# DECISION

File No.	2025-012-SP
Staff Report No.	PB-015-2025
Property Address	793175 County Road 124, Clearview
Proposal Description	Commercial Redevelopment – Proposal seeks demolition and removal of existing commercial building from the site and construction of a new approximately 820 m <sup>2</sup> commercial building for use as a Farm Co-operative consisting of the wholesale and retail sale of agricultural equipment, supplies and locally produced agricultural/horticultural products.

**Report To:** Chief Administrative Officer (CAO)  
**Report From:** Nick Ainley, Community Planner  
**Report Date:** April 23, 2025  
**Subject:** 793175 County Road 124, Clearview – Site Plan Approval

Schedule 'D': Site Plan & Elevations

SITE PLAN # 1

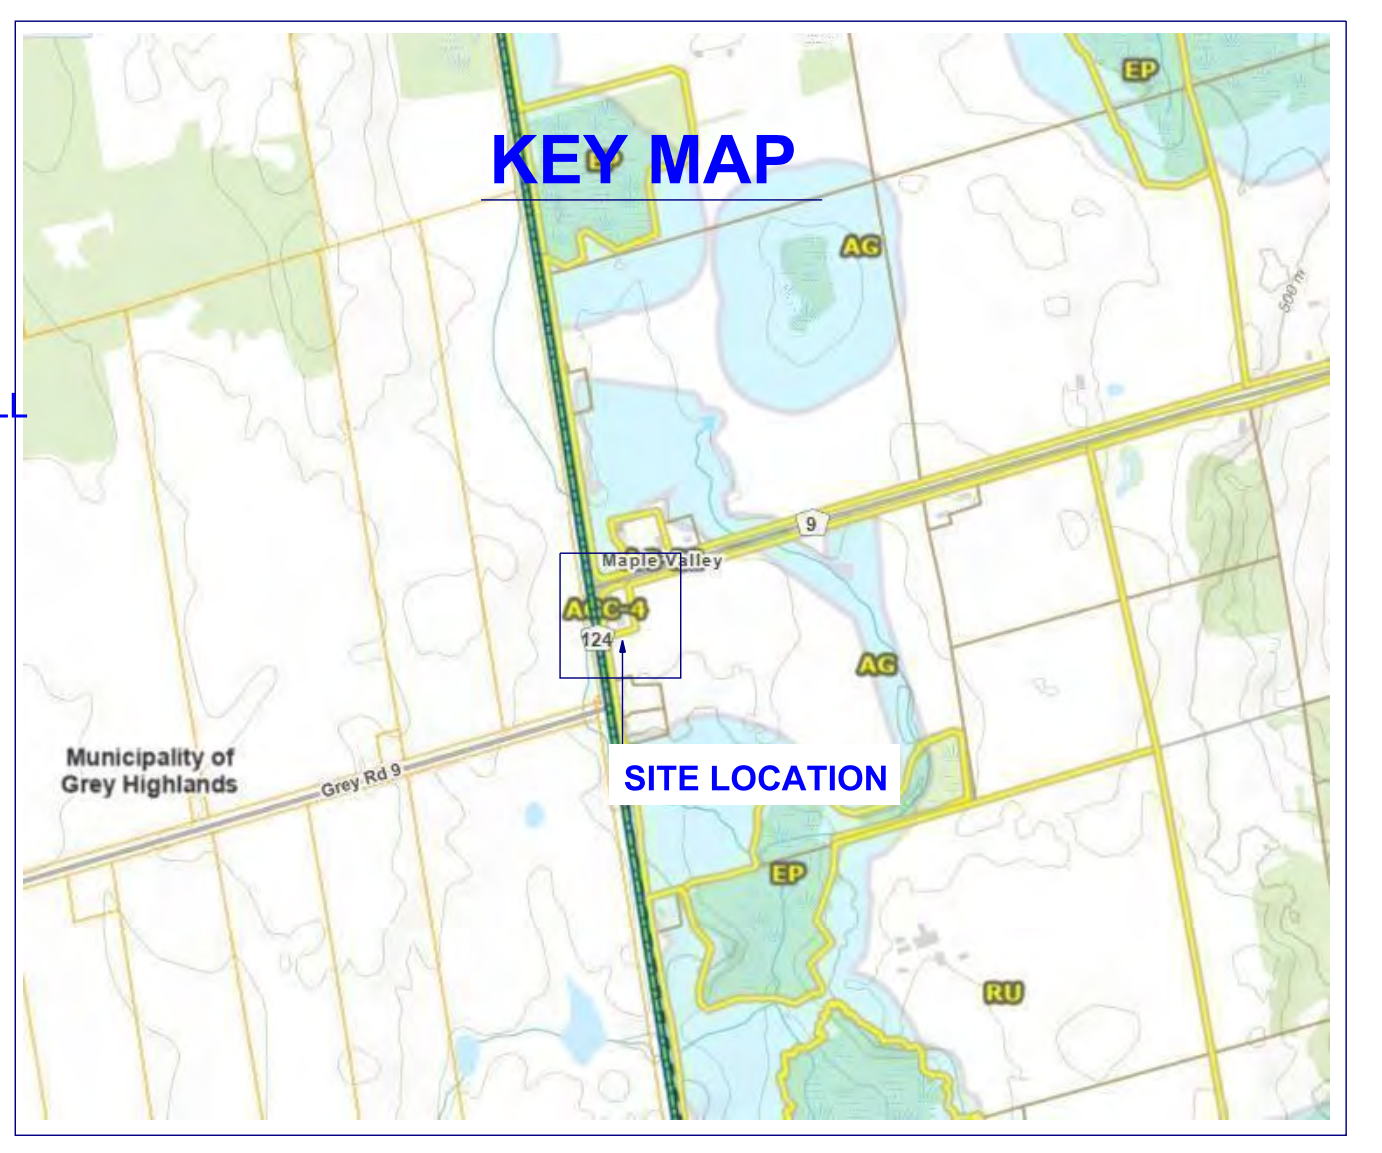
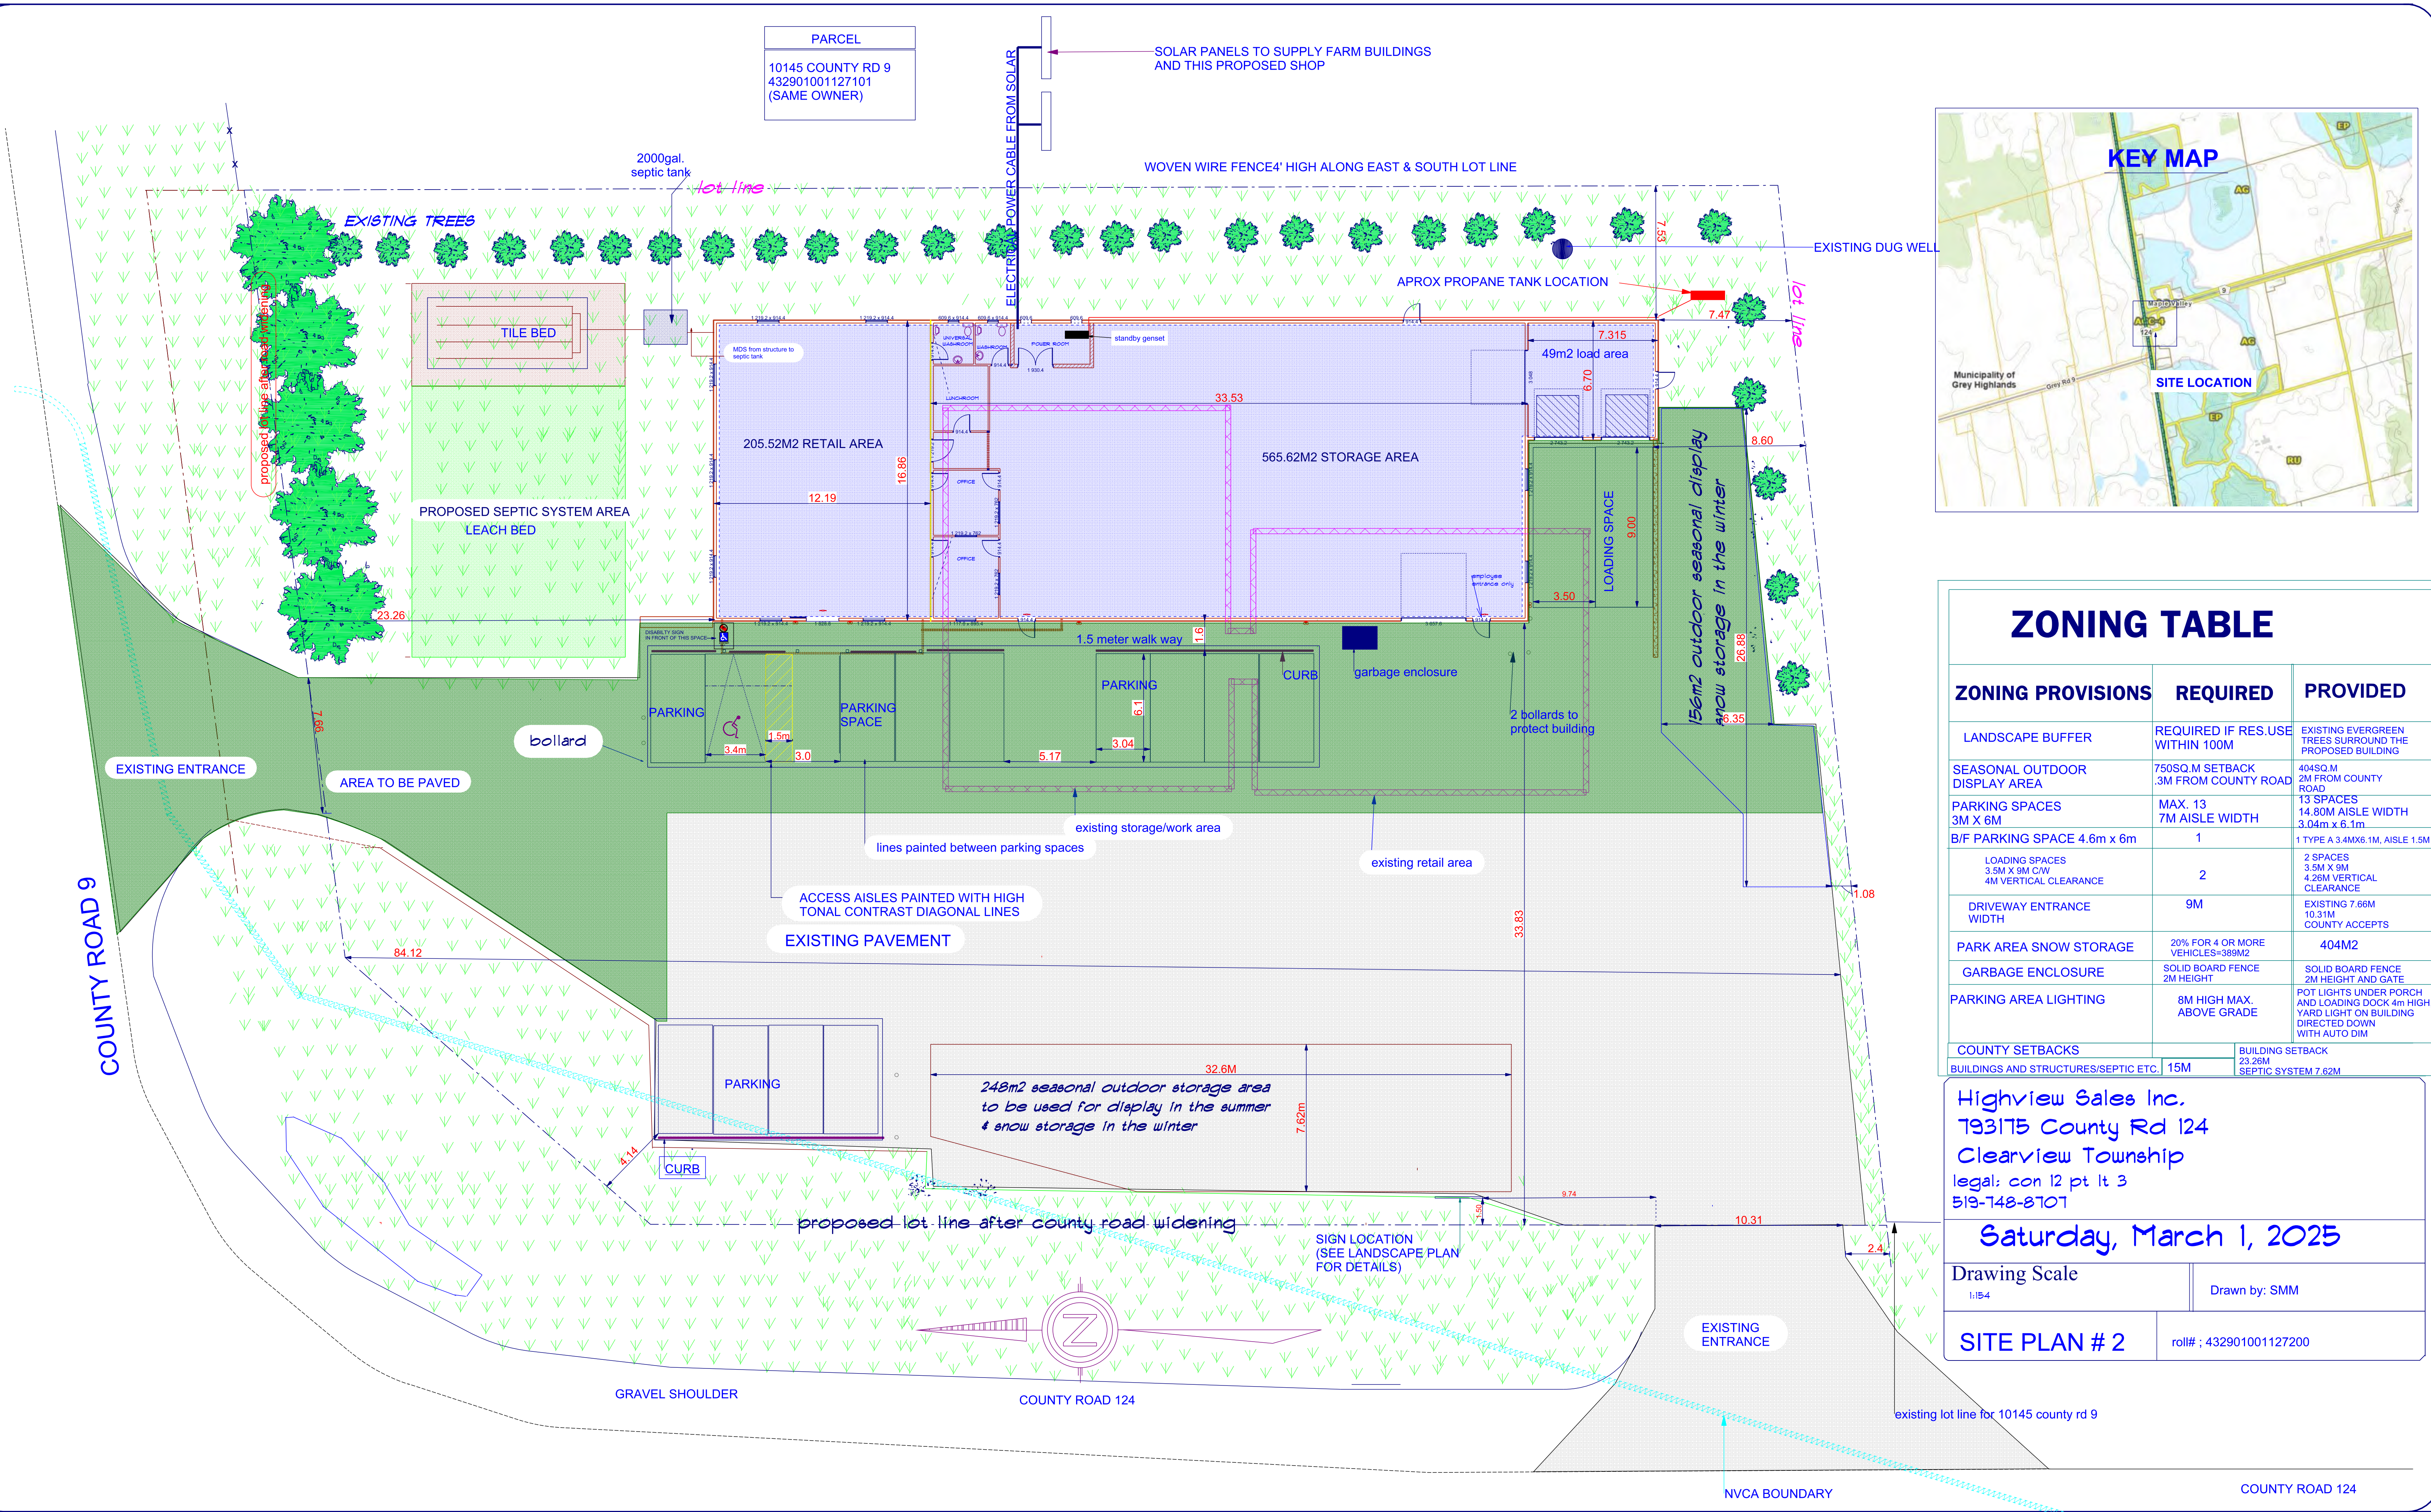
2.	That the final approved Site Plan and final approved engineering plans shall be updated to show the following to the satisfaction of the Planning and Building Department: <ul style="list-style-type: none"><li>a) Site Plan drawing(s) No. 1 &amp; 2 shall be consolidated into one (1) single Site Plan drawing.</li><li>b) The 'Zoning Tables' within the two (2) existing Site Plan drawings shall be consolidated into a single table and reformatted to use consistent text and font size.</li><li>c) Reference to existing building identified in opaque red outline shall be removed from the Site Plan.</li><li>d) To prevent vehicle access and/or parking, the approximately 5.17 m wide proposed pedestrian accessway located between parking spaces no. 5 &amp; 6 that abut the commercial building shall be delineated for pedestrian access only.</li><li>e) To prevent vehicle access and/or parking, the approximately 1.5 m wide proposed pedestrian aisle located between the barrier-free accessible aisle and parking space no. 3 that abut the commercial building shall be delineated for pedestrian access only.</li><li>f) The proposed SWM facilities in northwest area of the site shall be identified on Site Plan.</li></ul>

#	Condition
	<p>g) The location of any existing trees that are to remain within the northwest area of the subject lands following inclusion of SMW facilities shall be identified on Site Plan.</p> <p>h) Snow storage calculation provided within 'Zoning Table' shall be updated to include the total area of all paved surfaces.</p> <p>i) Proposed curbing of barrier-free parking space shall be revised to not interfere with 1.5 m wide accessible aisle.</p> <p>j) A note shall be included on Site Plan confirming that all proposed signage will comply with the Township Sign By-law 20-43.</p> <p>k) Reference to the proposed underground 'Electrical Power Cable' providing secondary/supplemental solar electrical supply to the subject lands from the adjacent property to the east (i.e. 101045 County Road 9) shall be removed from Site Plan.</p>

SITE PLAN # 2 roll# : 432901001127200

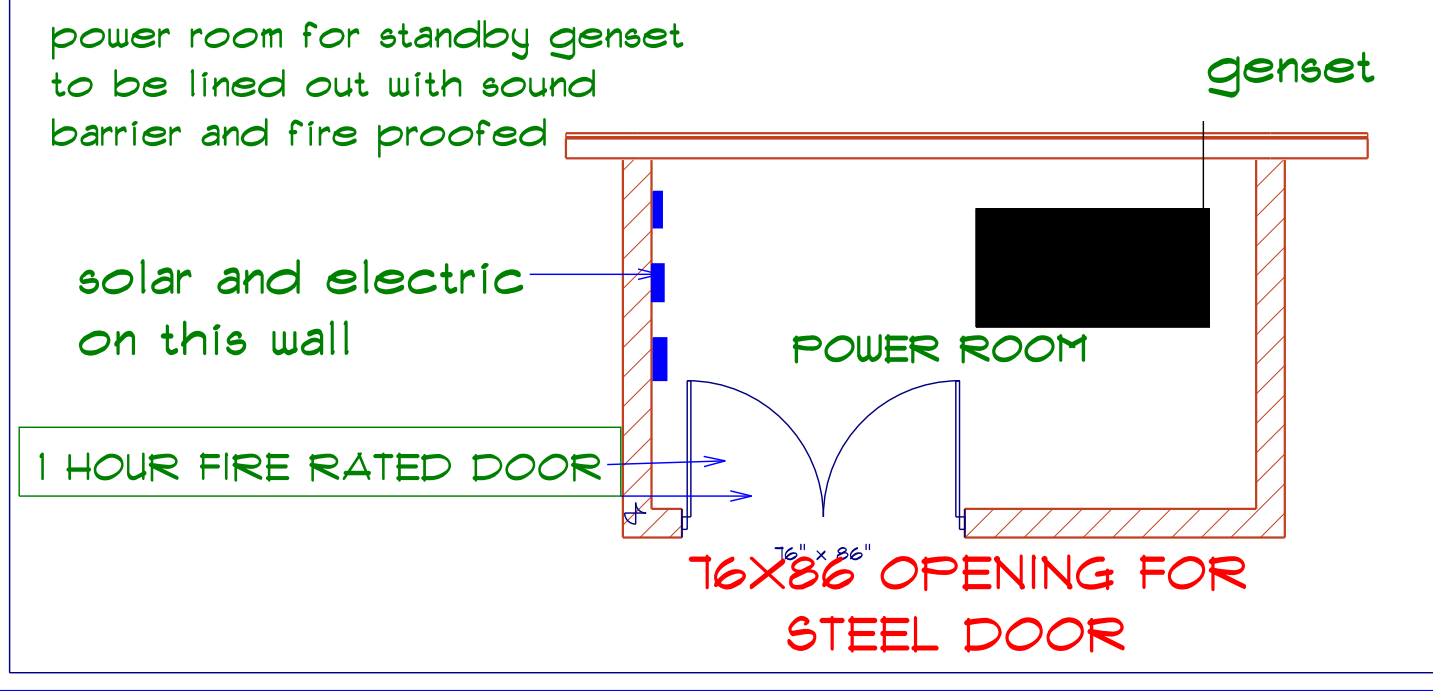
EXISTING TREES TO REMAIN ALONG NORTH AND EAST LOT LINES, EXISTING TREES TO BE REMOVED AT THE CORNER OF COUNTY ROAD 9 AND 124 FOR STORMWATER MANAGEMENT PURPOSES, AND EXISTING GRASSED AREAS TO REMAIN AS SHOWN IN DRAWINGS, EXISTING TREES ARE MAINLY CONIFEROUS TREES AND VARY IN SIZE FROM 4 METERS TO 10 METERS WITH 13 CONIFEROUS TREES ALONG 124 AND 9 CORNER WHICH WILL BE REMOVED, AND THE REST OF TREES ALONG COUNTY RD 9 AND EASTERN AND SOUTH LOT LINE, SOME TREES PARTIALLY ON COUNTY ROAD ALLOWANCE, (COUNTY ADVISED THESE CAN STAY)
